**Re: FortisBC Energy Inc. (FEI)**  
**Project No. 1599170**

**Application for a Certificate of Public Convenience and Necessity (CPCN) for  
the Tilbury Liquefied Natural Gas (LNG) Storage Expansion Project  
(Application)**

**Response to the British Columbia Utilities Commission (BCUC) Panel  
Information Request (IR) No. 1**

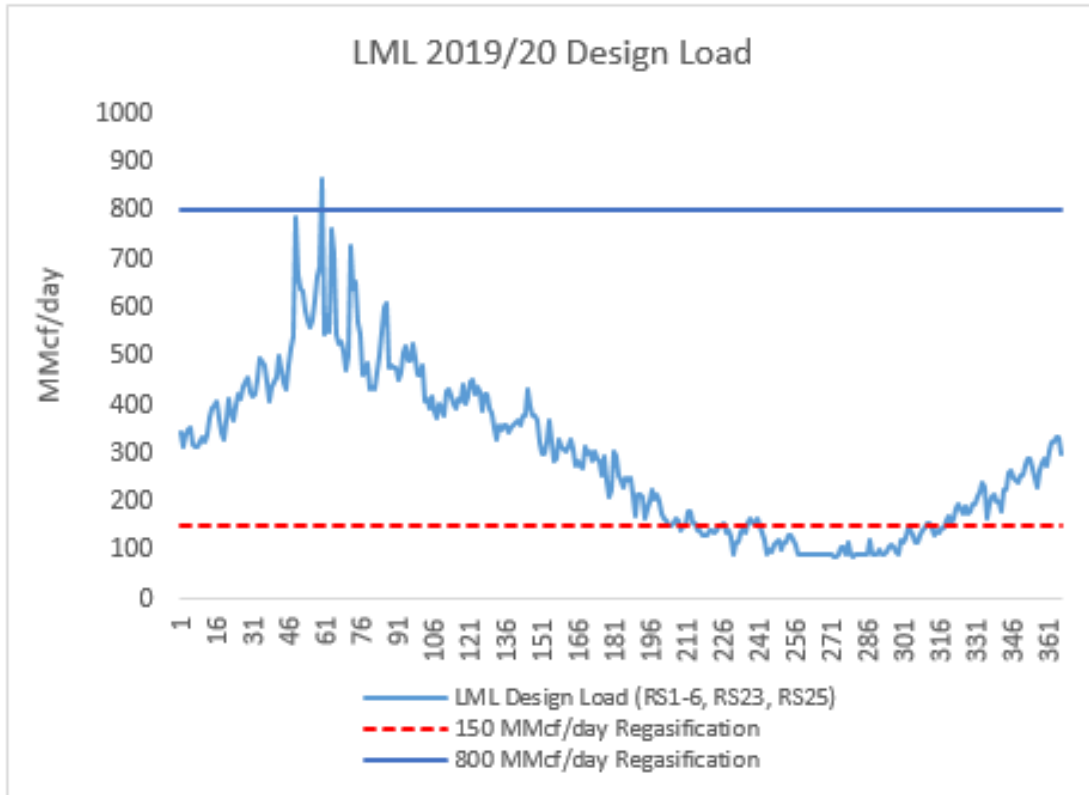
5.1.2 Please discuss whether either scenario described in the response to BCUC IR 69.1 would result in a pressure collapse assuming (i) FEI has 150MMCF/day regasification, and (ii) large customers can be curtailed in the absence of AMI remote disconnection.

The figure below shows the design load duration curve for 2019/20 and compares: (1) the proposed 3 Bcf tank with 800 MMcf/day of regasification capacity; and (2) the existing Tilbury regasification capacity of 150 MMcf/day. The figure demonstrates how, for approximately 245 days in a typical year (i.e., 67 percent of the year including all but the summer months when gas usage is low), customer demand greatly exceeds the existing Tilbury send-out capability of 150 MMcf/day. During this period (which includes all of the cold winter months), if a gas supply emergency similar to that described in the response to BCUC IR2 69.1 occurs and FEI is unable to rapidly shed excess customer demand, the pipeline line pack would be quickly consumed – resulting in a pressure collapse within the Lower Mainland transmission and distribution systems. Even with significant curtailment of large customers, in the absence of AMI technology, this imbalance between the higher system demand, a rapid loss of gas supply, and the much lower send-out capability, could not be corrected quickly enough during much of the year and a pressure collapse in the Lower Mainland system would be unavoidable.

Figure 6-3: 10-Year Renewable Gas Supply Forecast

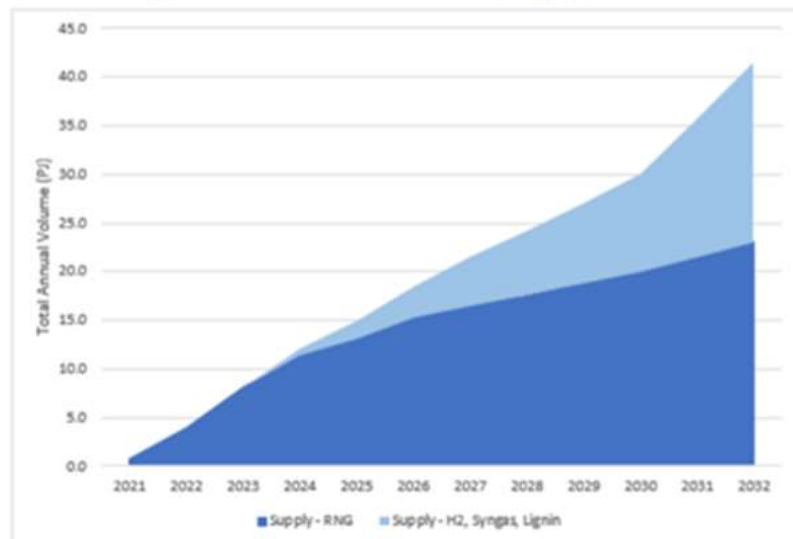
On page 78 of the Renewable Gas Program Review, FEI provided the following 10-year renewable gas supply forecast:
